This PCN affects our iMX RT1166/RT1176 uCOM boards (product numbers: EAC00377, EAC00381 and EAC00396).

Marking on top side. The board revision (rev C1 in this

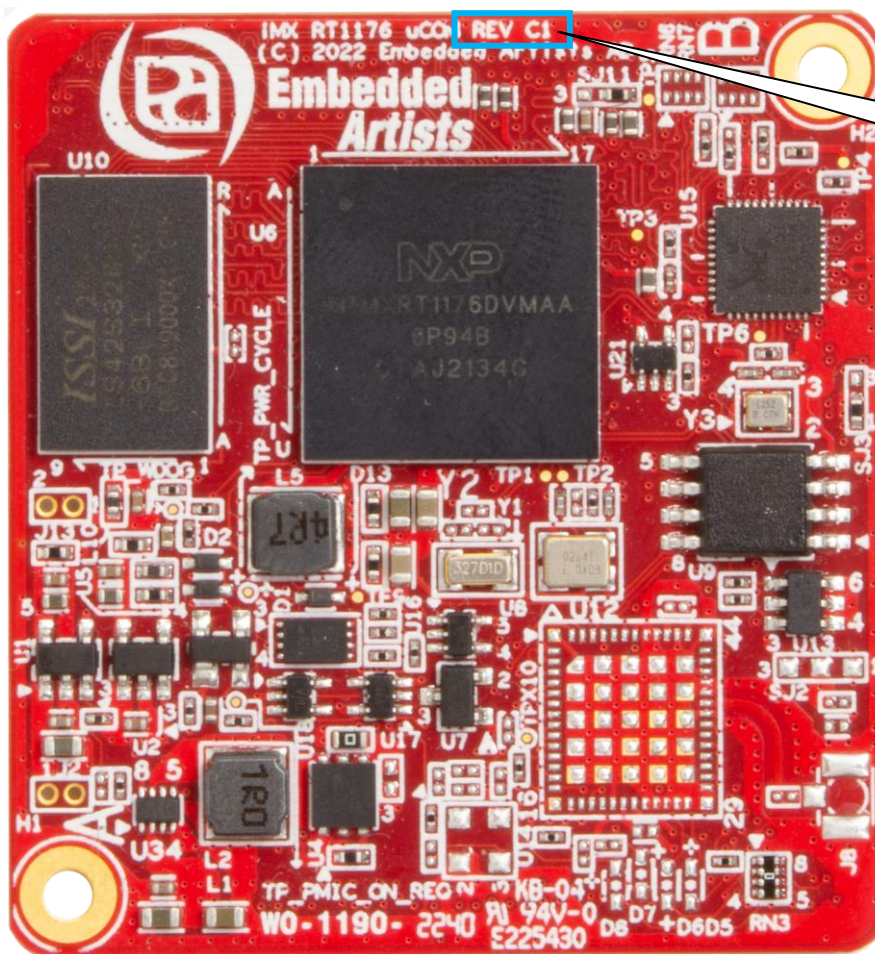
The new Gigabit Ethernet Phy is mounted on boards produced after December 2022. All boards from Embedded Artists have a marking: WO-XXXX-YYWW, where XXXX is the WO-number. YY is the year and WW is the week number when the board was produced.

The affected boards will have a WO-number above or including: $XXXX \geq 1190$, and have board revision "C1", or later, see picture below how to identify the board.
